SUBJECT: COMANCHE PEAK NUCLEAR POWER PLANT
DOCKET NO. 50-446
RELIEF REQUEST B-3 FOR UNIT 2 SECOND TEN YEAR INSERVICE INSPECTION
INTERVAL FROM 10CFR50.55a INSPECTION REQUIREMENTS DUE TO PHYSICAL
INTERFERENCES
(1998 EDITION OF ASME CODE, SECTION XI, 2000 ADDENDA
SECOND INTERVAL START DATE: AUGUST 3, 2004
SECOND INTERVAL END DATE: AUGUST 2, 2014)

COMANCHE PEAK NUCLEAR POWER PLANT UNIT 2
Relief Request Number B-3 for Unit 2 Second 10 Year ISI Interval
From 10CFR50.55a Inspection Requirements due to Physical Interferences
(Second 10-Year ISI Interval Start Date: August 3, 2004; End Date: August 2, 2014)

LIMITATION TO EXAMINATION

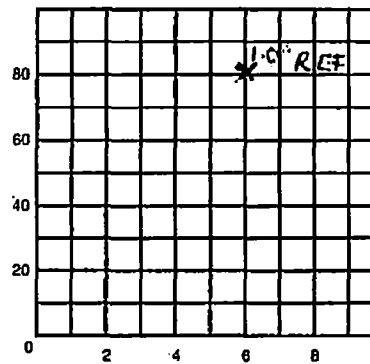
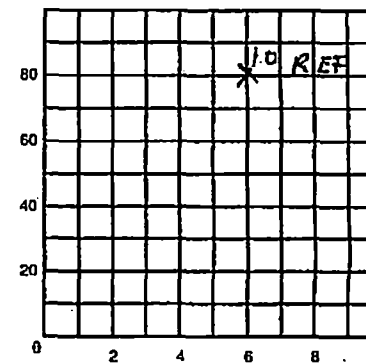
US SCAN = 100%

DS SCAN = 0%

CW SCAN = 100%

CCW SCAN = 100%

$$300\% \div 4 = \underline{75\%}$$

TOTAL COVERAGE ACHIEVED = 75%

DOWN STREAM (DS) SCAN LIMITED BY FLANGE

REPORT NO. 9UT11 STATION COMANCHE PEAK UNIT 2 PAGE 2 OF 3

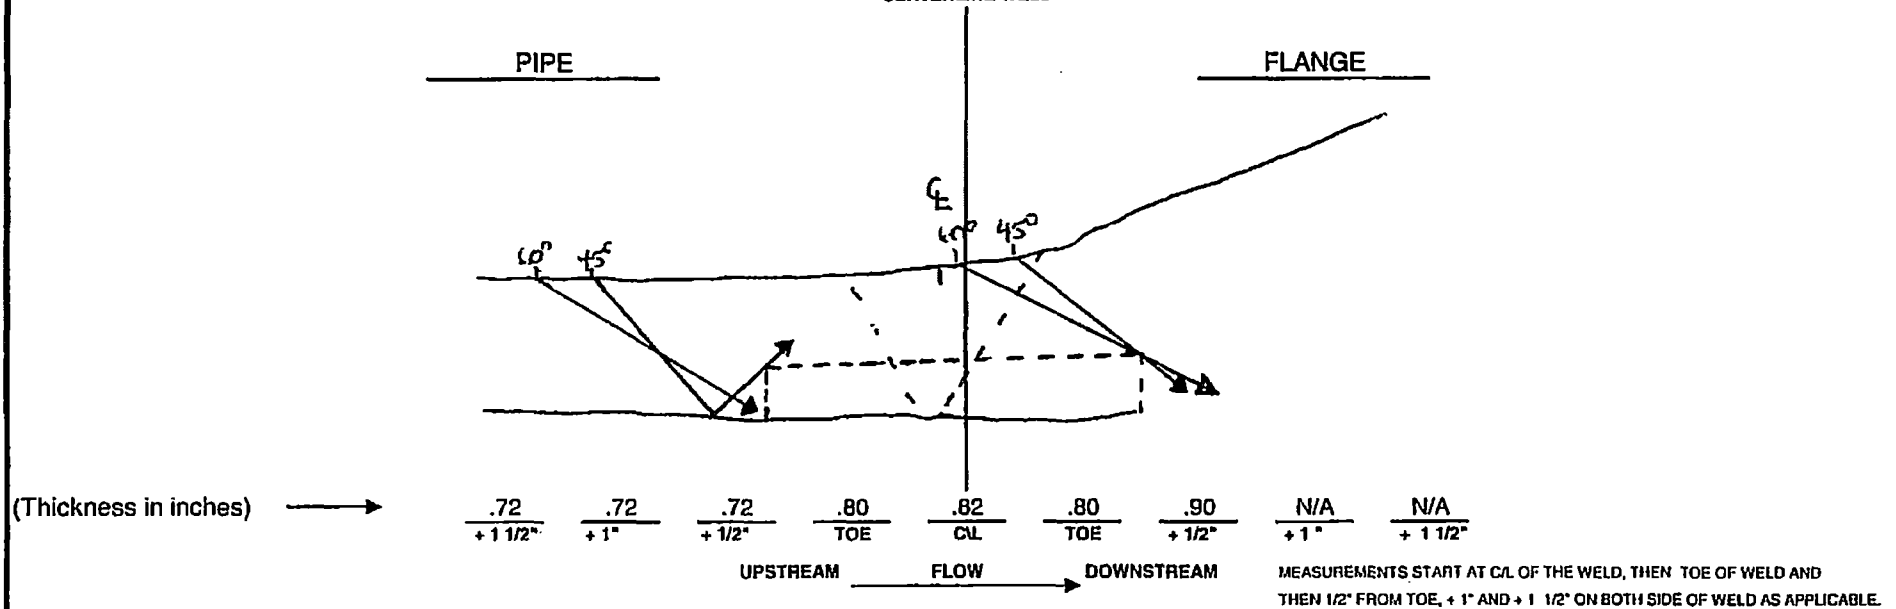
75% CODE COVERAGE ACHIEVED
